Z-50  
(2015)

# PRELIMINARY SITE PLAN

**ZONING COMMENTS:**

## **STAFF RECOMMENDATIONS**

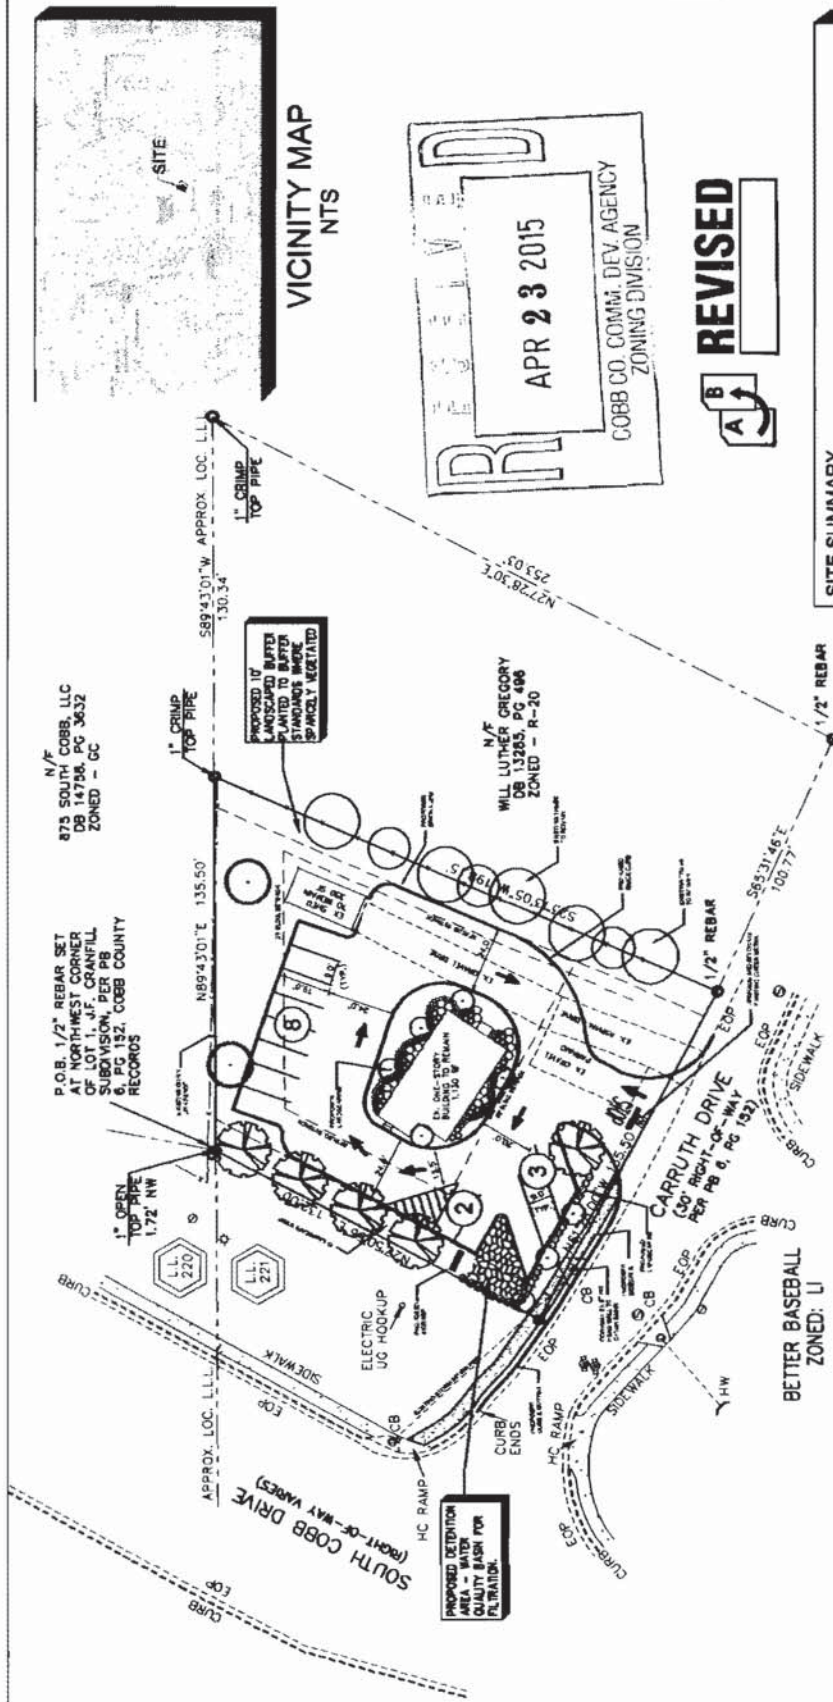
- Applicant is requesting the following contemporaneous variances:
- 1. Waive Front setback (Carruth Drive) from 75 feet to 38 feet;
  - 2. Waive the minimum lot size from 40,000 square feet to 21,254 square feet.

1. The entire site drains to the southwest to the right-of-way of Carruth Drive. There is a culvert within the right-of-way that conveys the site runoff across Carruth Drive into the existing Better Baseball Facility and the floodplain of Olley Creek.
2. The proposed detention area show on the site plan appears adequate to accommodate the water quality volume requirements of the site, but additional underground detention will likely be required to provide detention for the development. There is sufficient area available under the parking and drive lanes to accommodate the facility.
